## ENGINEERING CHANGE NOTICE

1. ECN 614152

5. Project Title/No./Work Order No. Hanford Patrol Academy Demolition Sites Sampling and Analysis Plan	6. Bldg./Sys./Fac. No. N/A	7. Approval Designator N/A JB

8. Document Numbers Changed by this ECN (includes sheet no. and rev.) WHC-SD-EN-TI-284, Rev 0, Page 4	9. Related ECN No(s). N/A	10. Related PO No. N/A
11a. Modification Work  [ ] Yes (fill out Blk. 11b) [X] No (NA Blks. 11b, 11c, 11d)	11b. Work Package No. N/A	11c. Modification Work Complete R. K. Bhatia <i>R. K. Bhatia</i> 11/30/94 Cog. Engineer Signature & Date	11d. Restored to Original Condition (Temp. or Standby ECN only) F. A. Ruck <i>ppa</i> <i>R. K. Bhatia</i> 11/30/94 Cog. Engineer Signature & Date

Figure 3. Soil Sampling Locations/Depth Closure Area No. 2.

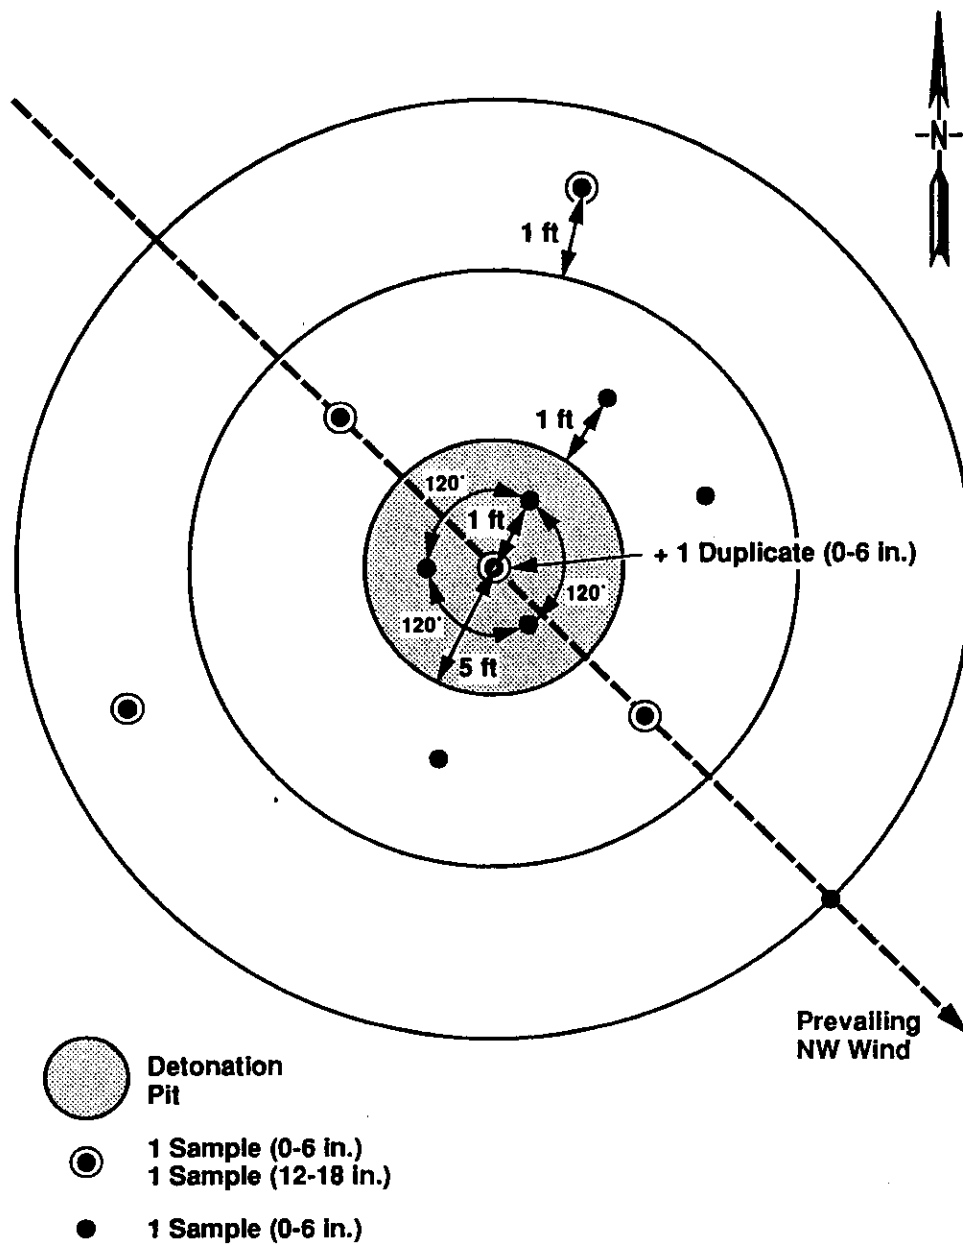
12. Description of Change Figure 3 incorrectly shows the radius of the detonation to be 2 ft. Figure 3 will be revised to show the radius of the detonation pit to be 5 ft.			
13a. Justification (mark one) Criteria Change <input type="checkbox"/> Design Improvement <input type="checkbox"/> Environmental <input type="checkbox"/> As-Found <input type="checkbox"/> Facilitate Const. <input type="checkbox"/> Const. Error/Omission <input type="checkbox"/> Design Error/Omission <input type="checkbox"/>			
13b. Justification Details Change the radius of the detonation pit to 5 ft.

(7) In Figure 3 incorrectly shows the radius of the detonation pit as 2 ft. Figure 3 will be revised to show the correct radius, 5 ft. *ECN-604152*
